**Globemaster Corridor Specific Plan
Program EIR/EIS (SCH No. 2018091021)
EIR-03-17**

1 Introduction to the Final PEIR/PEIS

This chapter of the Final Program Environmental Impact Report (PEIR) and Program Environmental Impact Statement (PEIS) includes a copy of all comment letters that were submitted during the public review period for the Draft PEIR/PEIS (State Clearinghouse No. 2018091021) for the proposed Globemaster Corridor Specific Plan (GCSP; Proposed Project), along with responses to comments in accordance with California Environmental Quality Act (CEQA) Guidelines Section 15088 and National Environmental Protection Act. The 45-day public review period for the Draft PEIR/PEIS began on August 3, 2020 and ended on September 17, 2020.

FIGURE 3.13-1

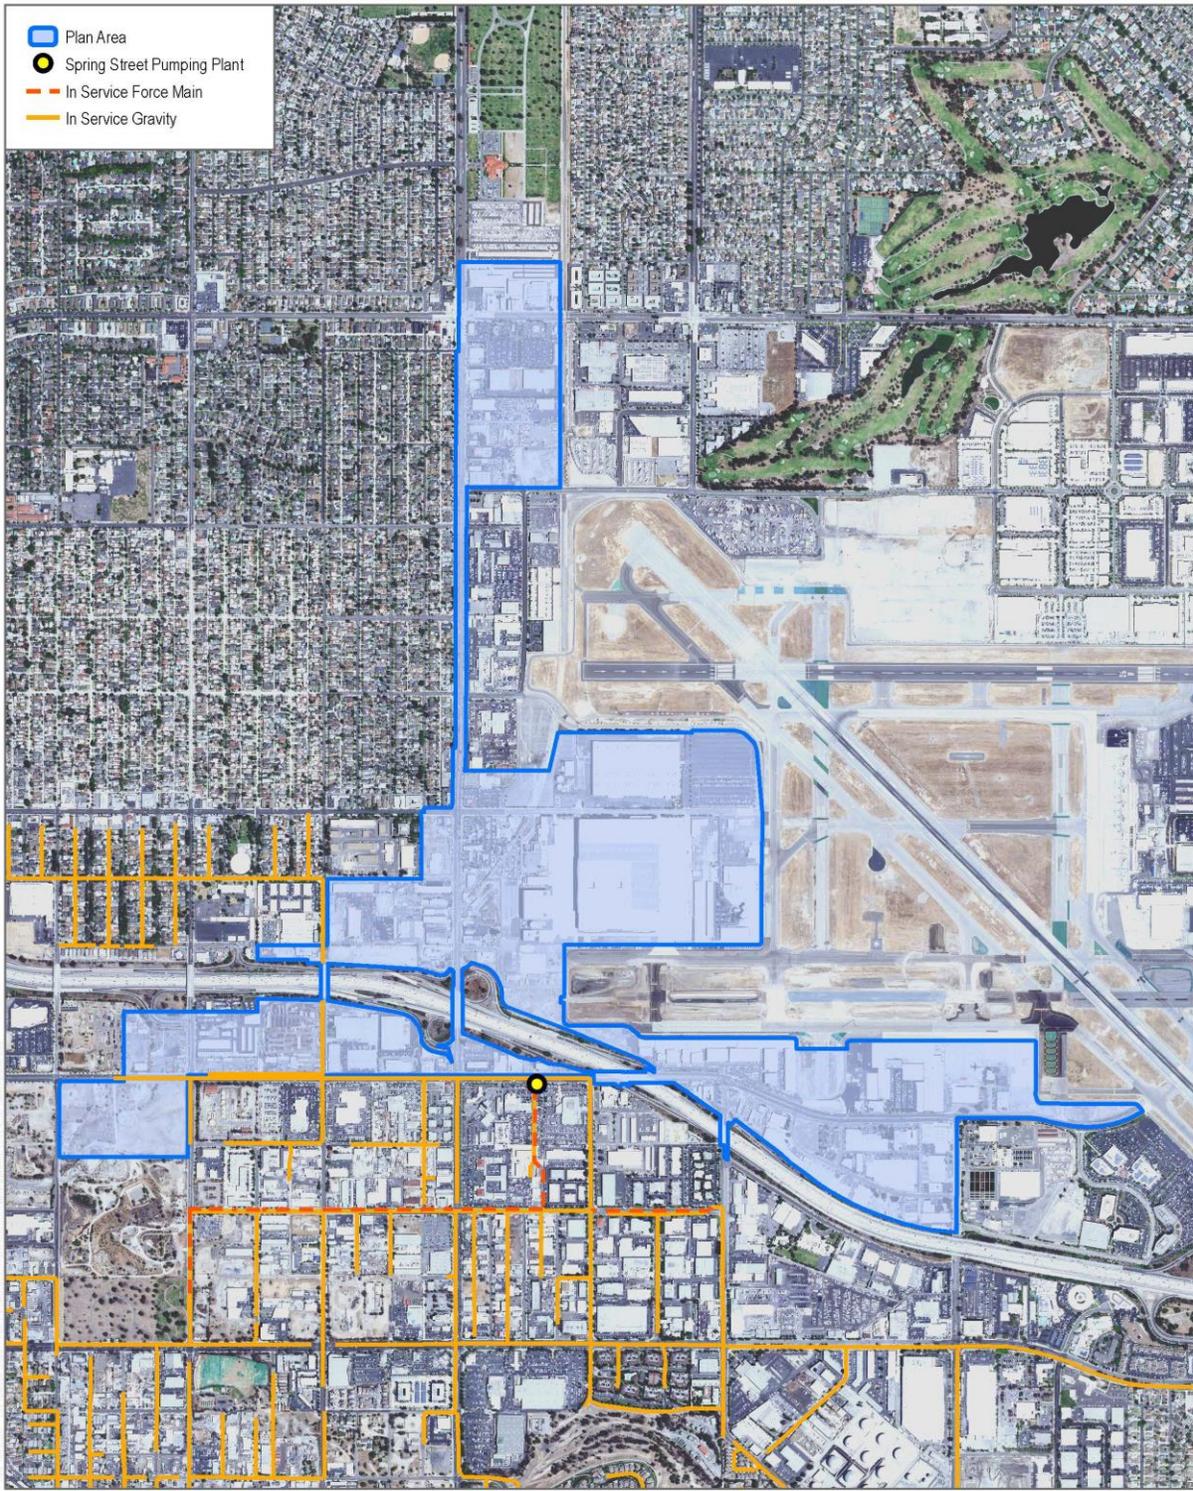
7-4 The commenter raises issue with Section 3.13.1, Existing Conditions, in Section 3.13, Utilities and Service Systems, of the Draft PEIR/PEIS because it does not provide a detailed discussion on how wastewater is conveyed from the Plan Area to the LACSD trunk mains. As provided in Chapter 3, Changes to the Draft PEIR/PEIS, of this Final PEIR/PEIS, this section has been revised to include a more thorough discussion of LACSD's trunk lines within the Plan Area. In addition, a new figure (Figure 3.13-1, LACSD Sewer Lines) is provided in this Final PEIR/PEIS. Additionally, Chapter 3 of this Final PEIR/PEIS notes that sewer lines within the Plan Area would generally flow south toward Spring Street and then east toward the Spring Street Pumping Plant. Given the programmatic nature of the analysis, the existing conditions did not describe each existing lateral and local connections from within the Plan Area towards the LACSD facilities. Additionally, MM-UTIL-1 requires project-specific analysis that would describe the existing sewer facilities operated by LBWD and their flows towards LACSD trunk mains.

Figure 3.13-1, LACSD Sewer Facilities, has been added based on a comment provided from the Long Beach Water Department to include a more thorough discussion of LACSD's trunk lines within the Plan Area. See the revised figure attached to the end of this chapter of the Final PEIR/PEIS. The proposed revision does not alter the analysis or conclusions presented in the Draft PEIR/PEIS.
